UNITED STATES PATENT AND TRADEMARK OFFICE

10/516,410

Office Action Summary	Application No. 10/516,410	Applicant(s) LINKE ET AL.	
	Examiner JUSTIN KRAUSE	Art Unit 3682

DETAILED ACTION

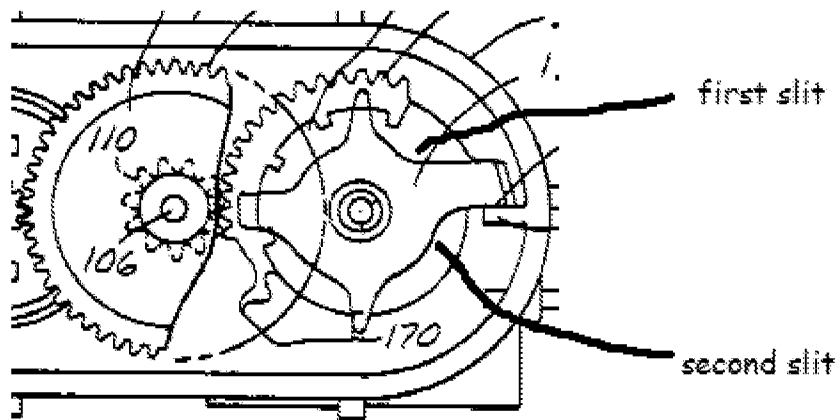
Regarding claims 4 and 14, the first member is integrally formed with the gearwheel by first and second slits (see figure below).

Regarding claim 5, the width of the first and second slits increases radially towards the rotation axis of the gear.

Regarding claim 6, the slits end in a cavity having a radius substantially larger than the width of the slits.
